April 28, 2023

RE: DB22-0010 Charbonneau Marina Modifications Response to Letter of Incomplete Application.

Pioneer Project No.: 999-146.7

**PRELIMINARY MARINA PARKING LOT GRADING & EROSION CONTROL PLAN**  
 CHARBONNEAU COUNTY CLUB - MARINA MODIFICATIONS  
 8755 SW ILLAHEE COURT, WILSONVILLE, OREGON

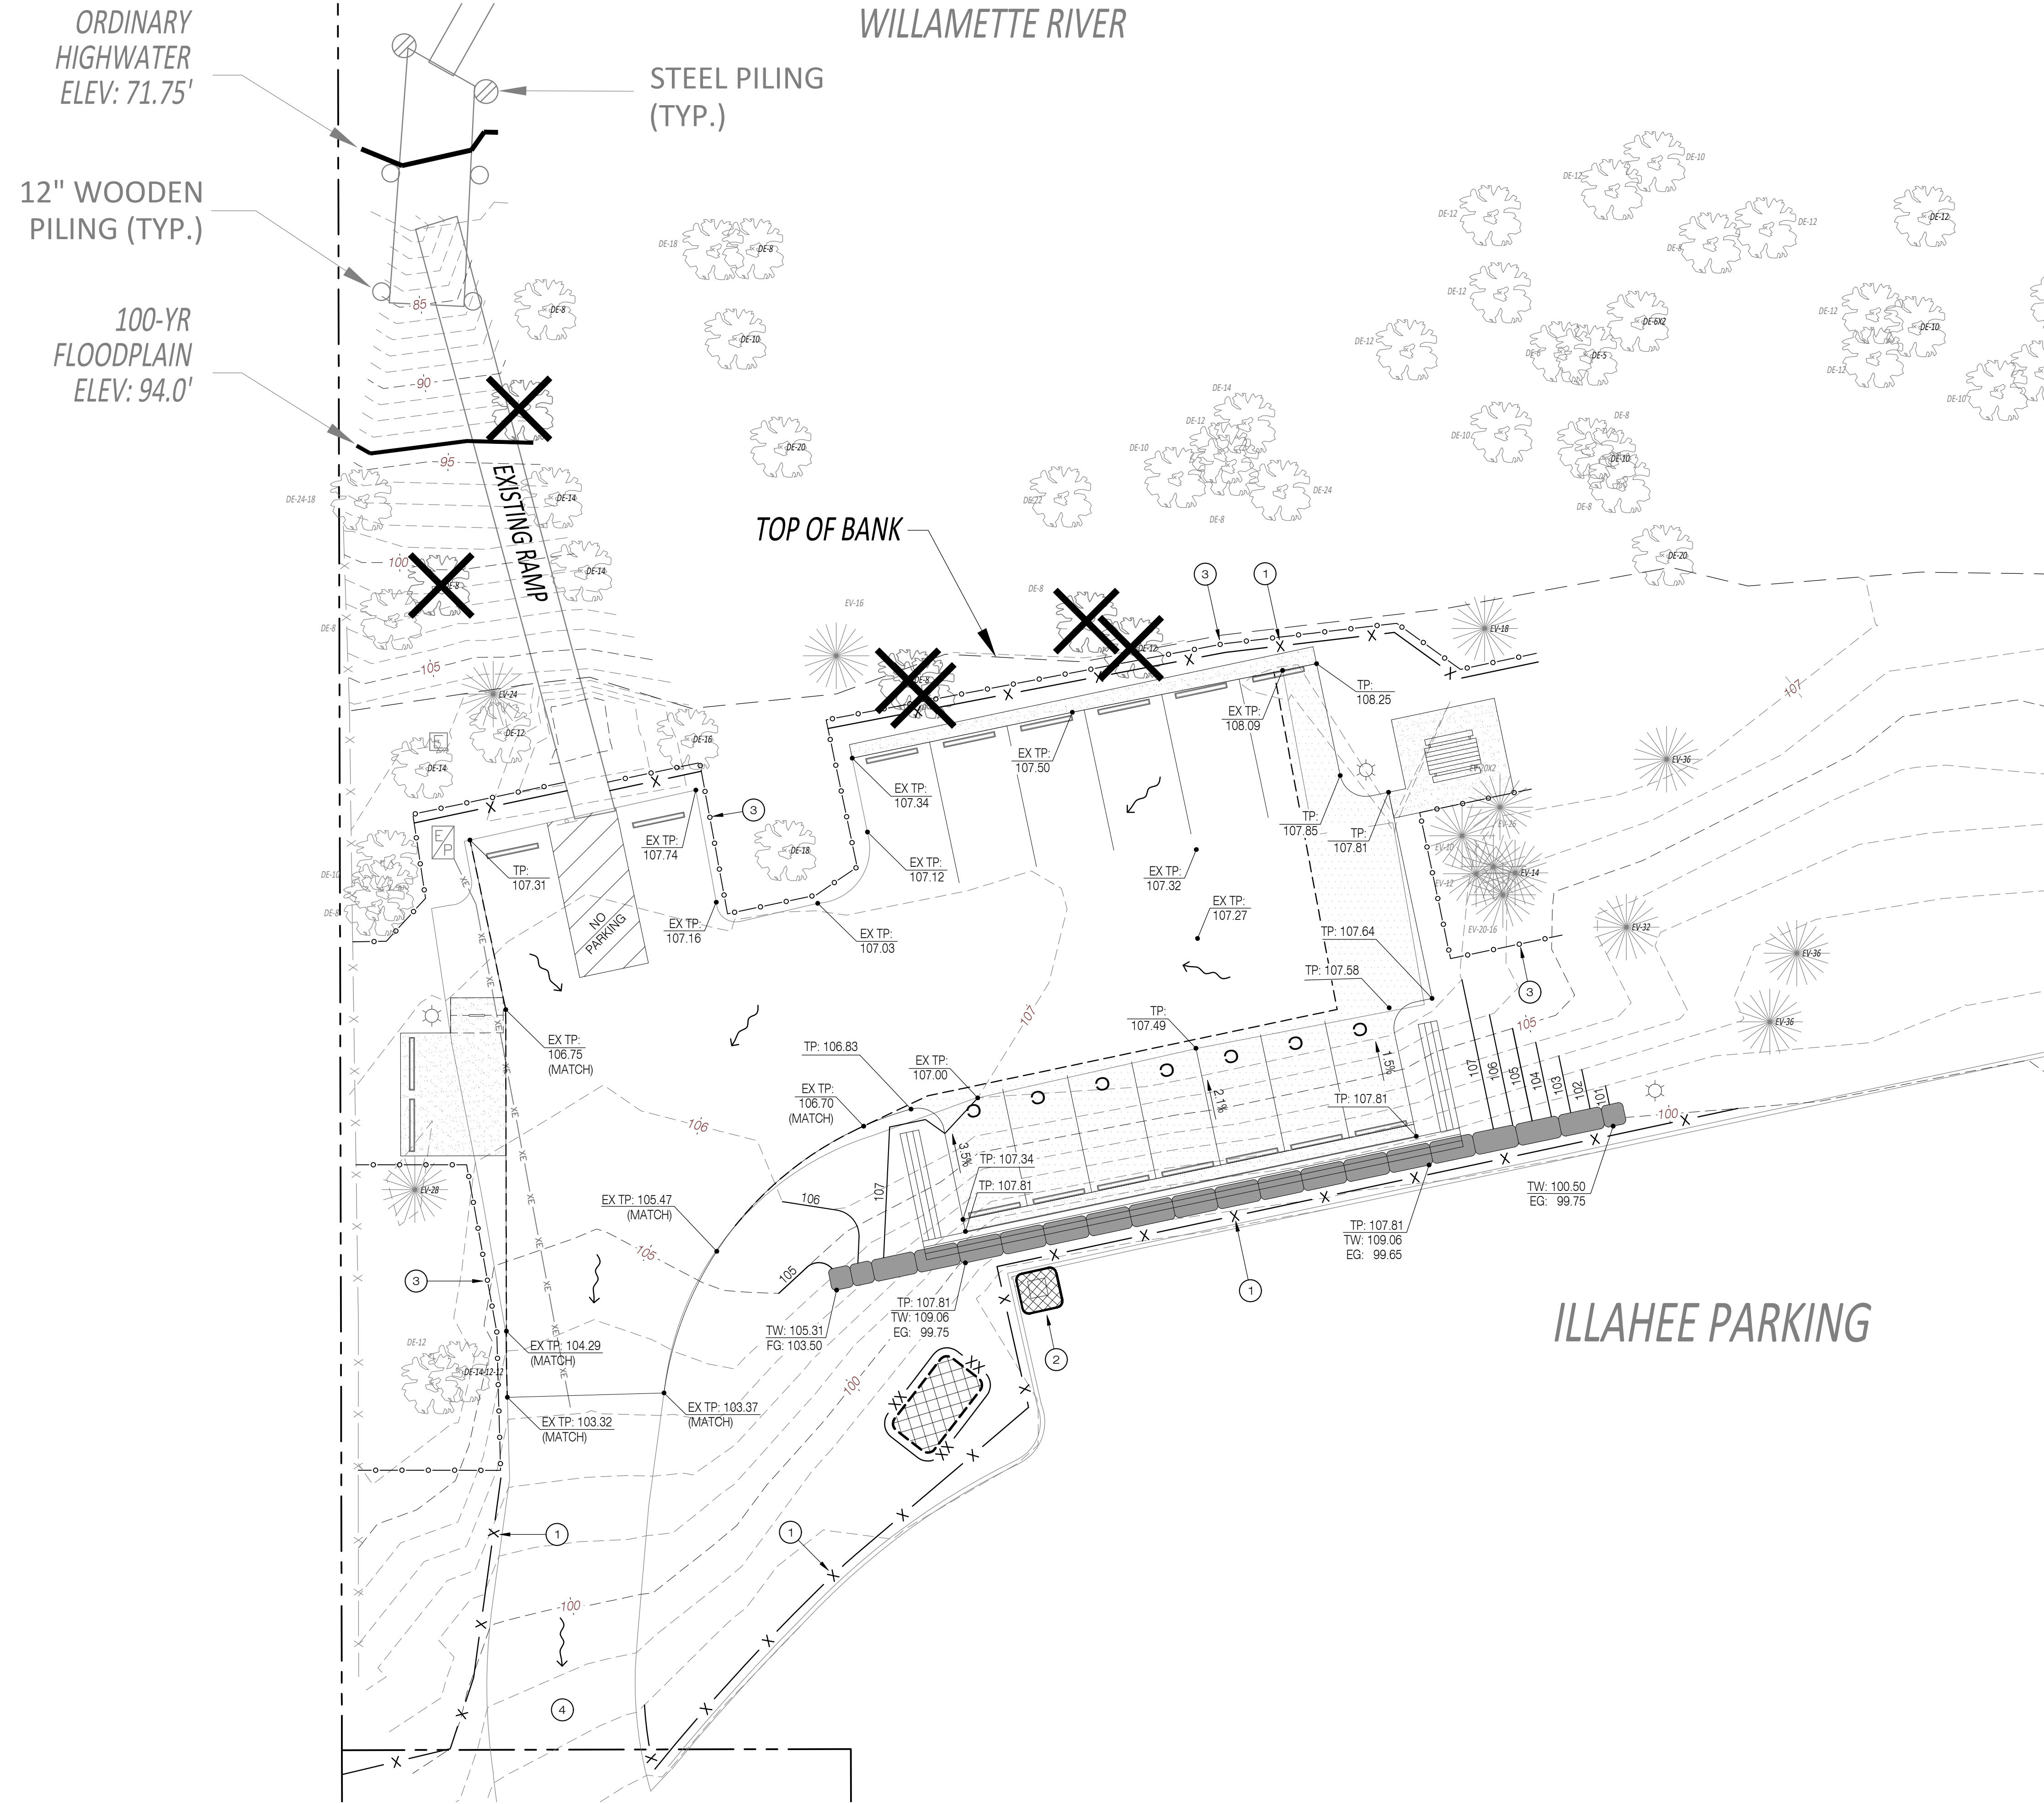
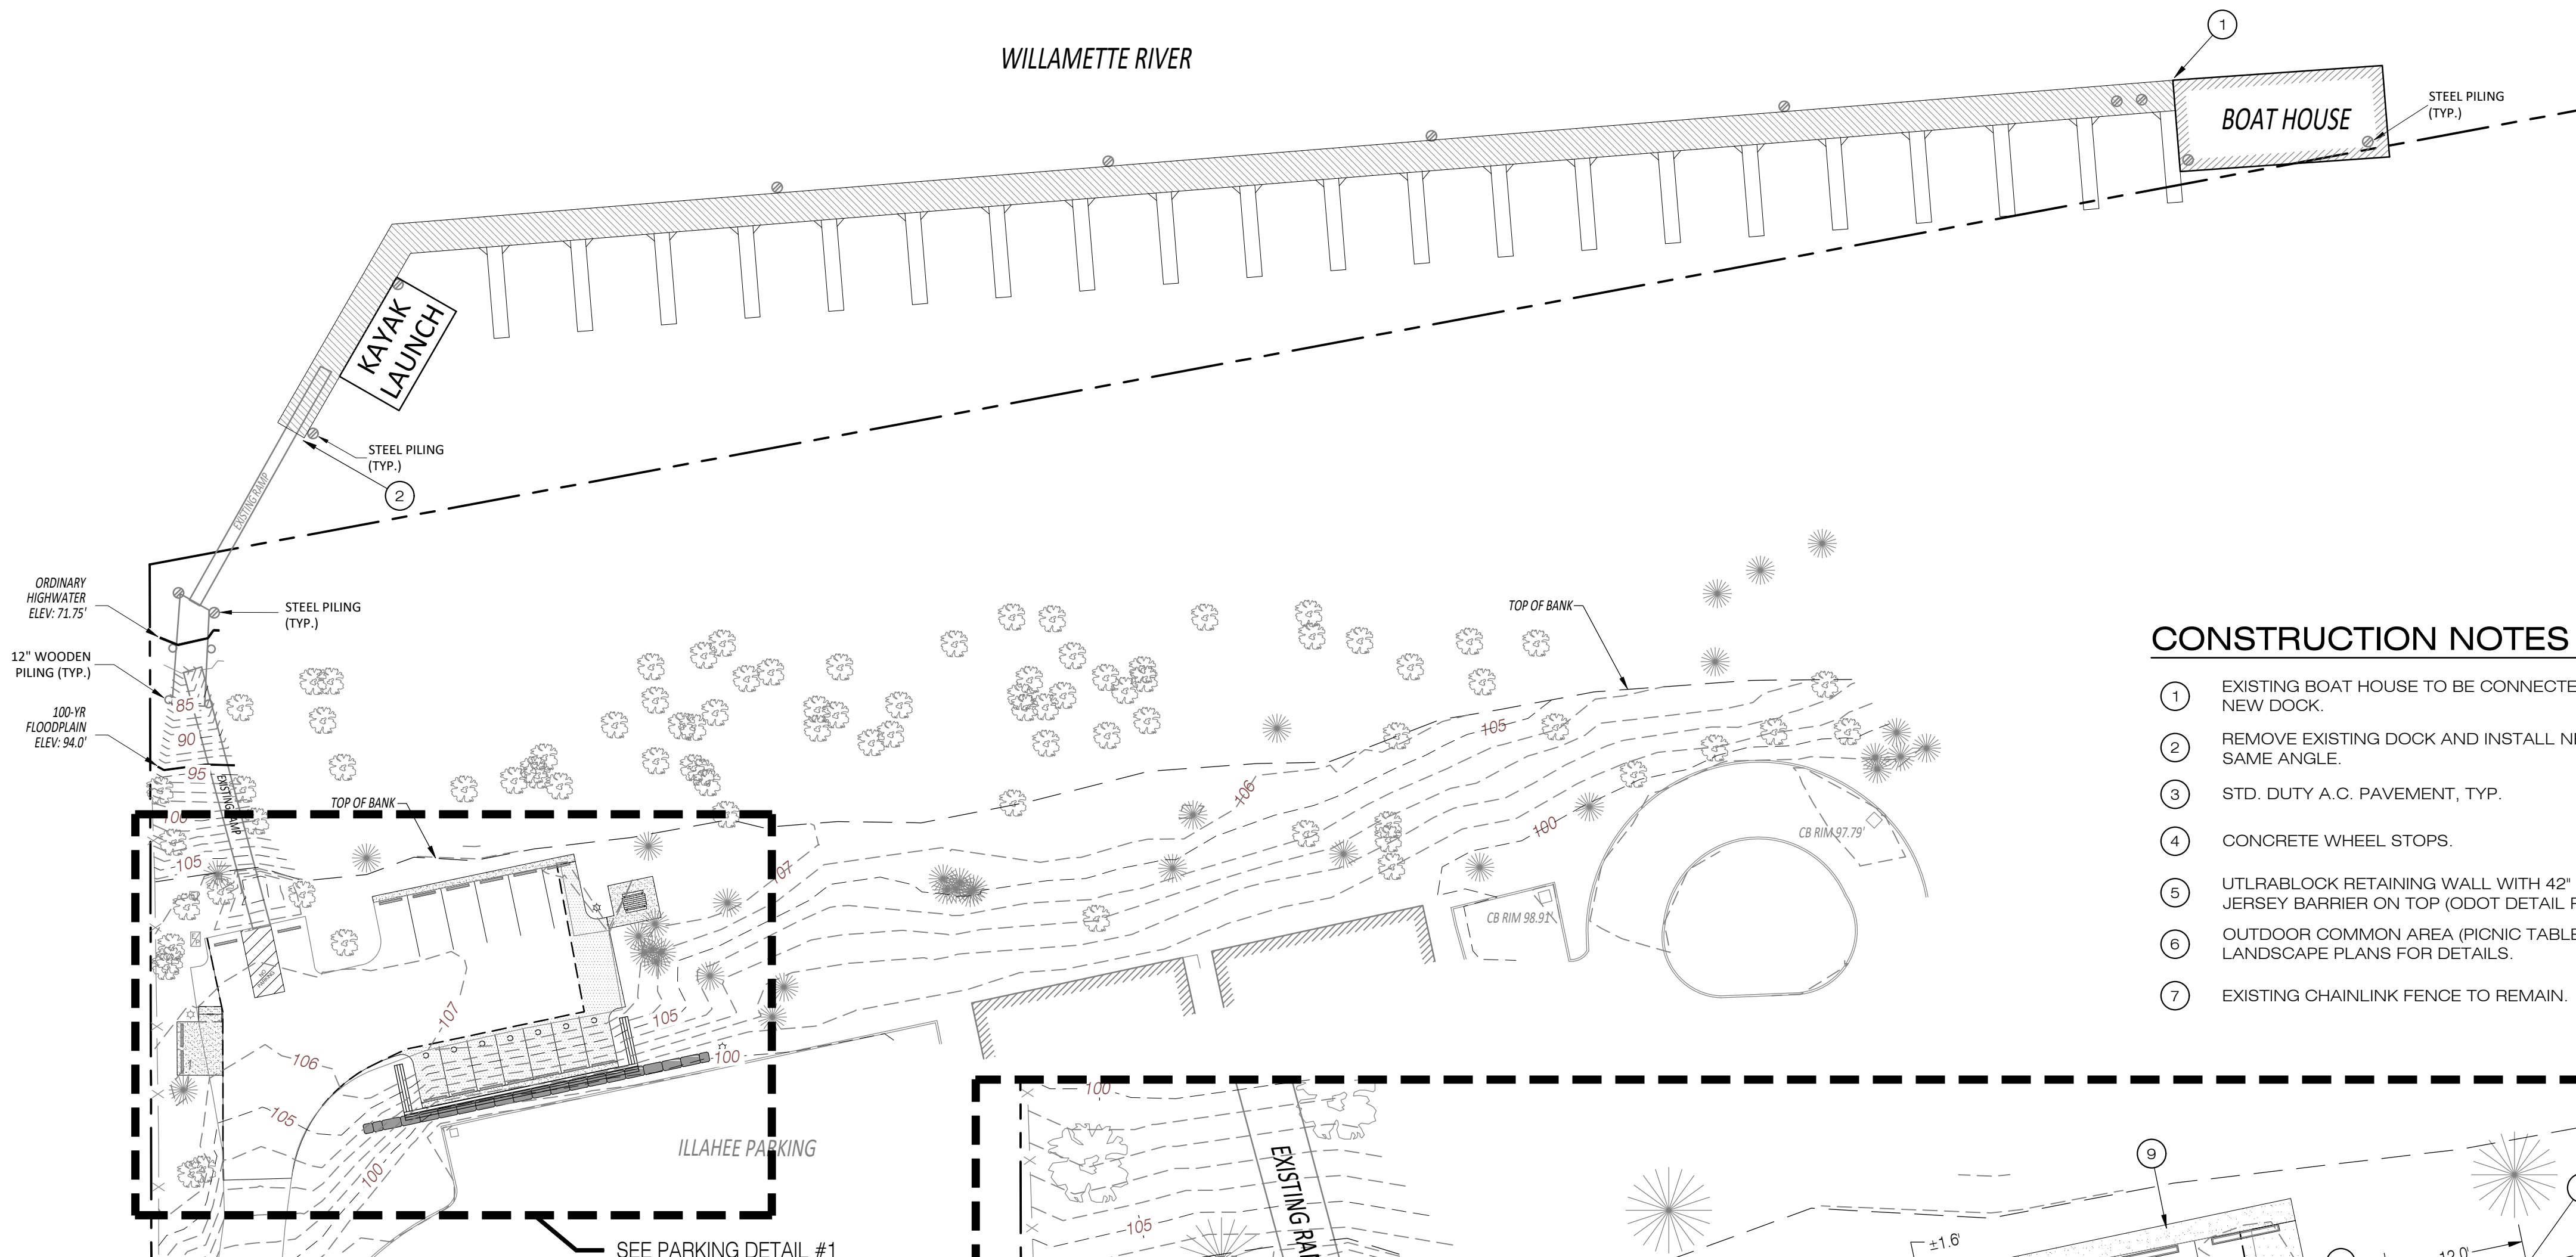
*✦ Grading Plan – 4.140(.09)C.6*

- o Submit grading plan to address area of new parking spaces, retaining wall, and any other areas of ground disturbance.*
- o Show flood plain elevation contour.*

**RESPONSE:** A Grading Plan has been provided that addresses the new parking spaces, retaining wall, and any other areas of ground disturbance.

The flood plain level and ordinary high water level are shown on the updated Plan Set.

**PARKING DETAIL #1**  
SCALE: 1"=10' (H)

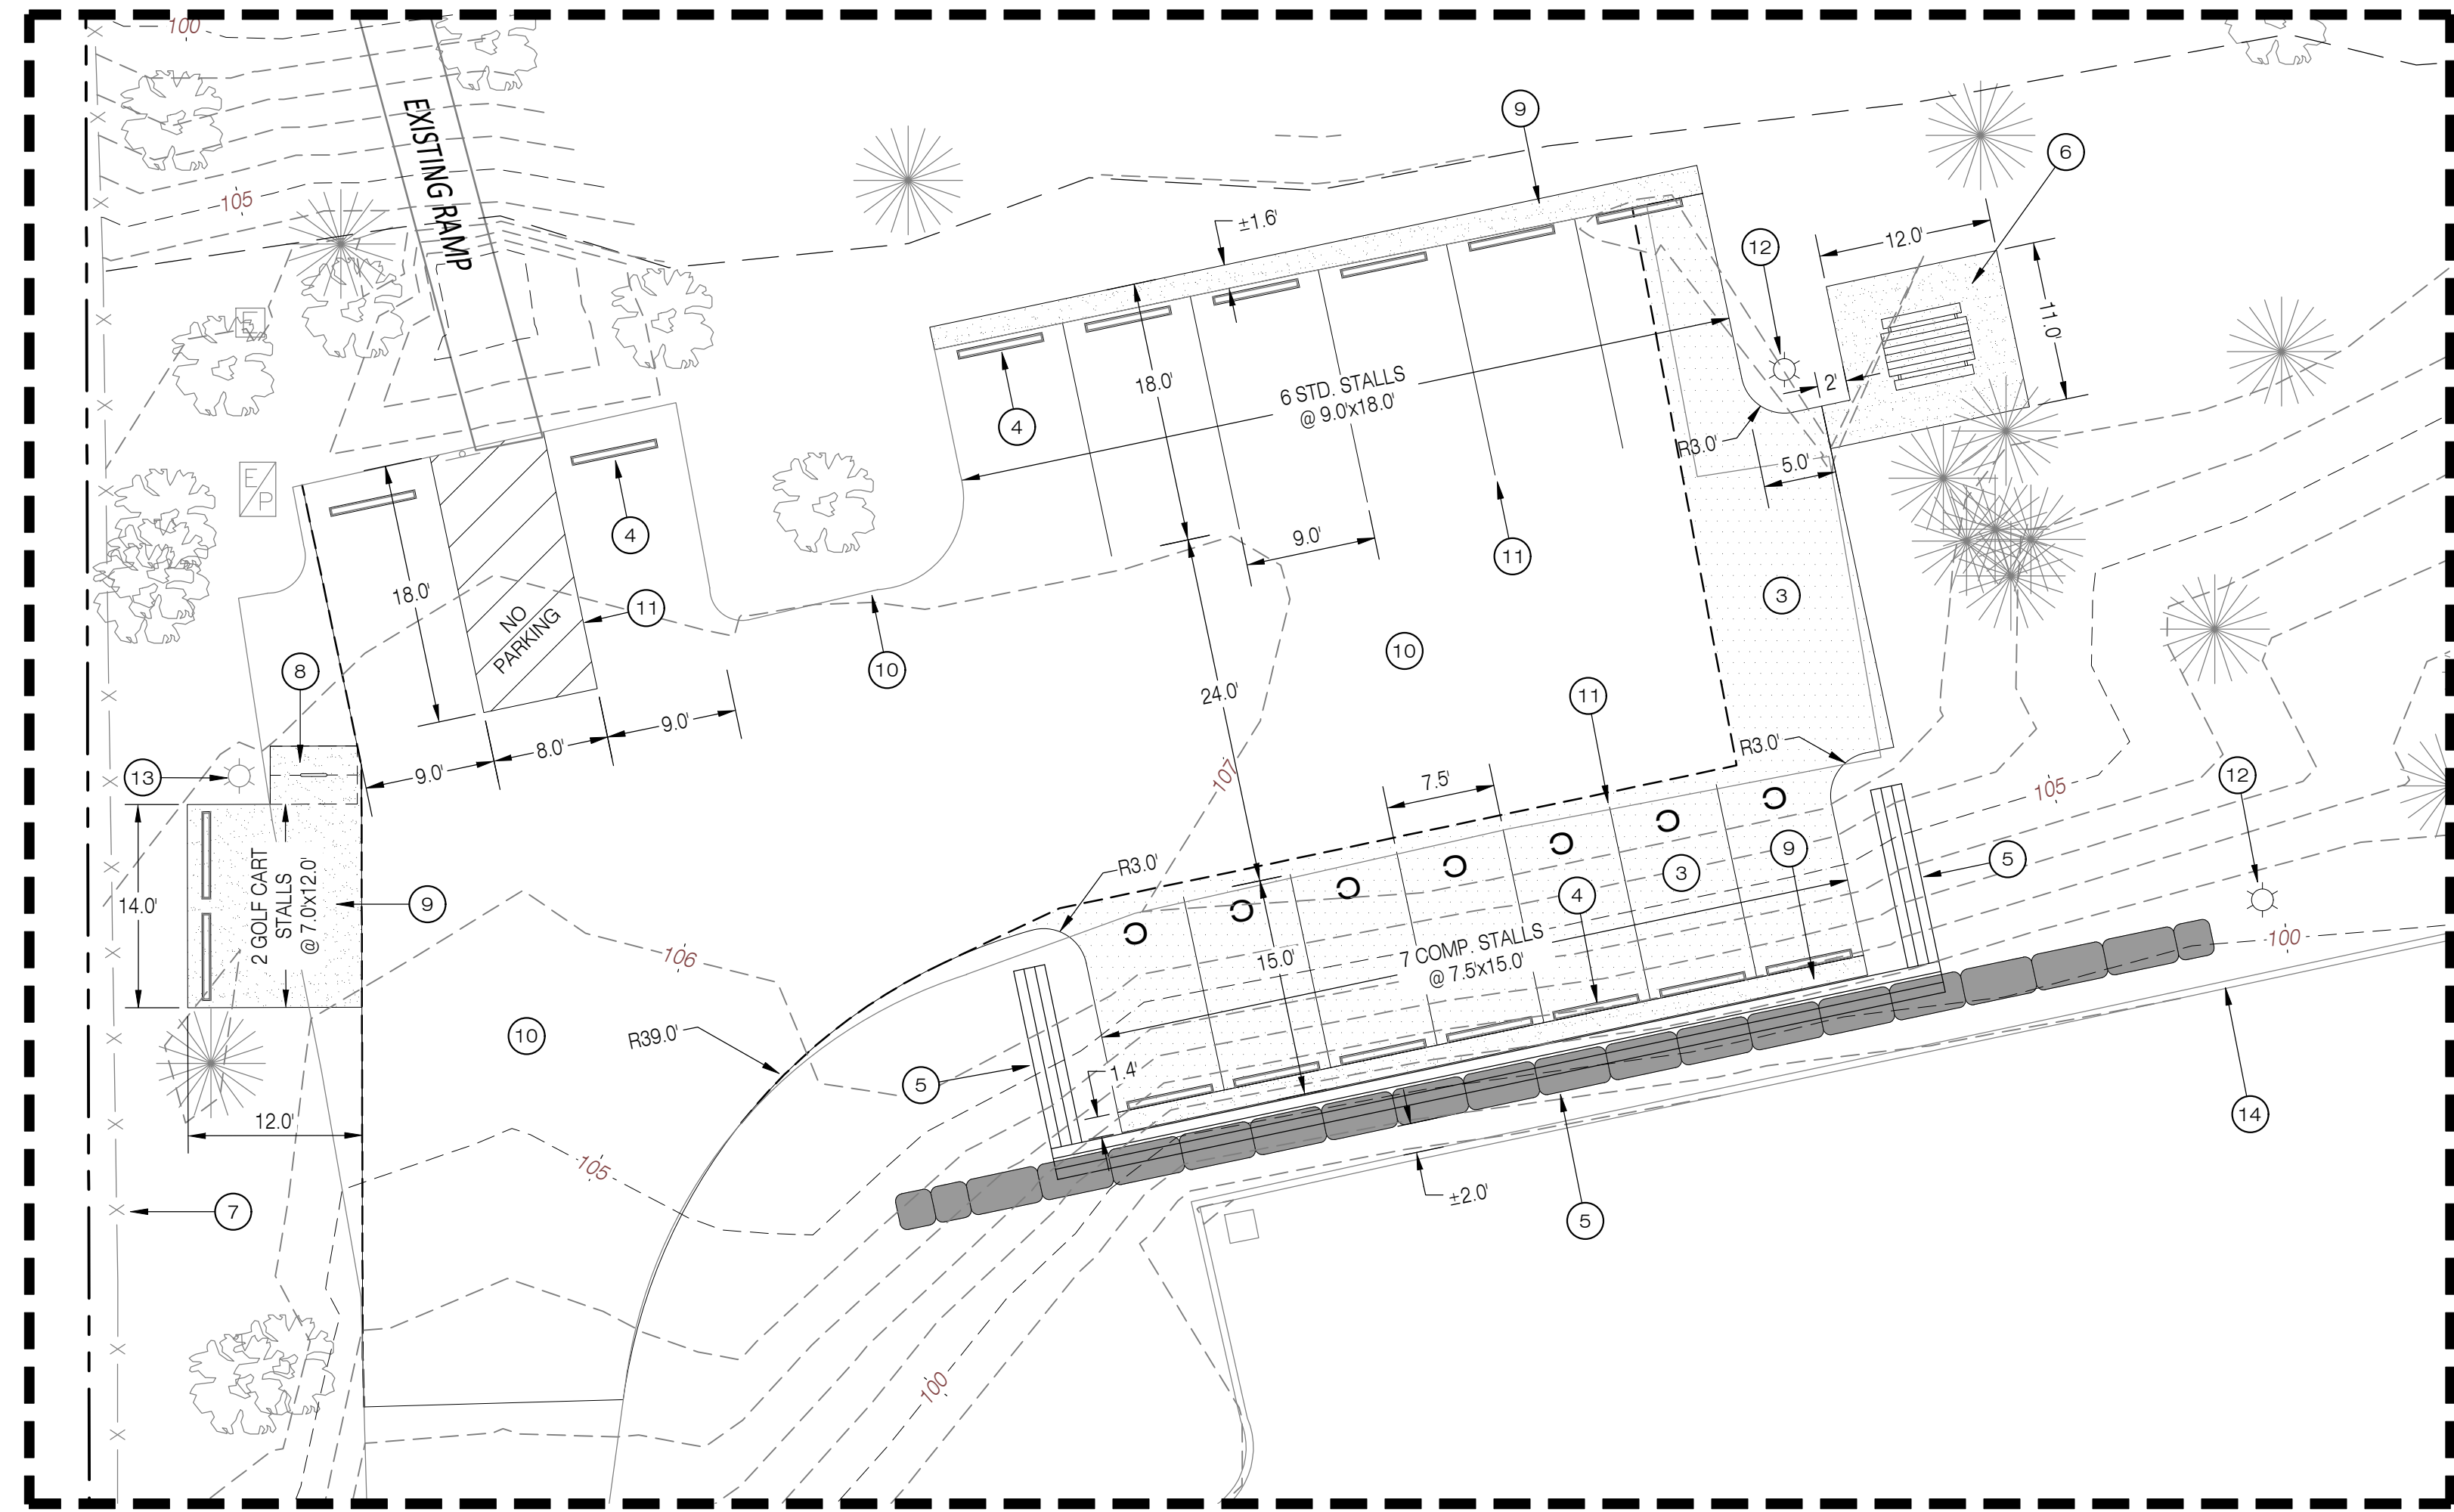
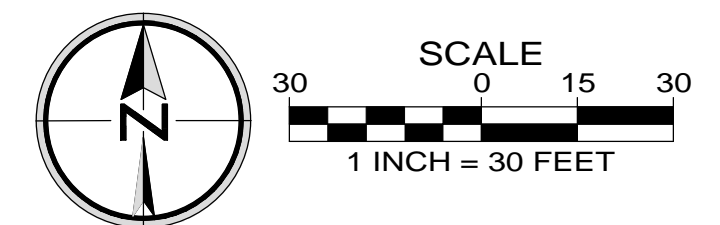
E. The parking lot retaining wall is capped by a jersey barrier that appears to be less than 42" in height which is the height needed for guardrails to prevent falls when an adjacent change in elevation is greater than 30". The elevation difference between the upper and lower parking lots is significantly more than 30". It is recommended that a guardrail be installed on top of the jersey barrier to provide additional height to achieve the 42" guardrail height.

**RESPONSE:** The updated plans provide for concrete GM rails so other guardrailing is not needed.
